Minor corrections to the Operative Hurunui District Plan

The following memo outlines the correction of minor errors identified in the Hurunui District Plan – Plan Change 5 decisions version. The correction of this error is pursuant to clause 20A of Schedule 1 to the Resource Management Act 1991 ('RMA').

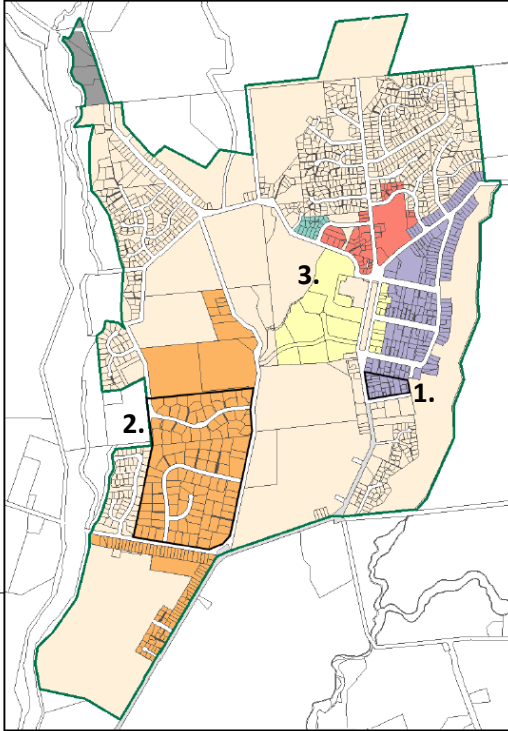
<p>Make changes to the planning maps:</p> <ol style="list-style-type: none"> 1. Change the applicable design area of the identified area from Old Town to General. 2. Reduce the extent of the Brick design area (orange) to the area outlined. Outside of 	<p>These mapping changes were notified as part of Plan Change 5 (Hanmer Springs design standards) to the Hurunui District Plan. No submissions were received in relation to these changes.</p>

the identified area the applicable design area will be the General design area.

3. Combine the Amuri Business (yellow) and Town Centre Business (red) design areas into one Business design area.

The planning map changes were missed when the provision list was compiled for the Hearing Panel decision.
